SERVICE BULLETIN

Classification: EC09-010	Reference: NTB09-046	Date: June 12, 2009
-----------------------------	-------------------------	------------------------

2004 – 2005 ALTIMA; DTC P0420 WITH SULEV QR25DE ENGINE

Figure 2

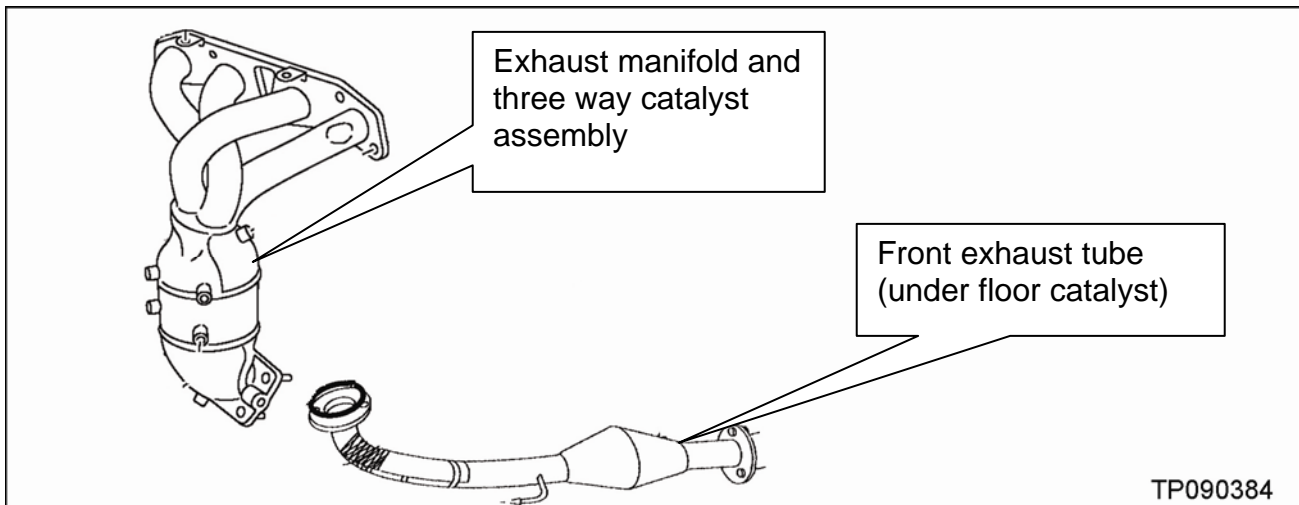
3. Install the Repair Kit listed in the Parts Information.

- Repair Kit includes exhaust manifold and three way catalyst assembly and the front exhaust tube (under floor catalyst).
- Refer to the Service Manual as needed for replacement information.
- **Make sure to use the parts listed in the Parts Information of this bulletin.**
- Transfer heat shields and sensors from the old manifold and front tube to the new ones.
- Replace gaskets, seals, and nuts supplied in the Repair Kit.
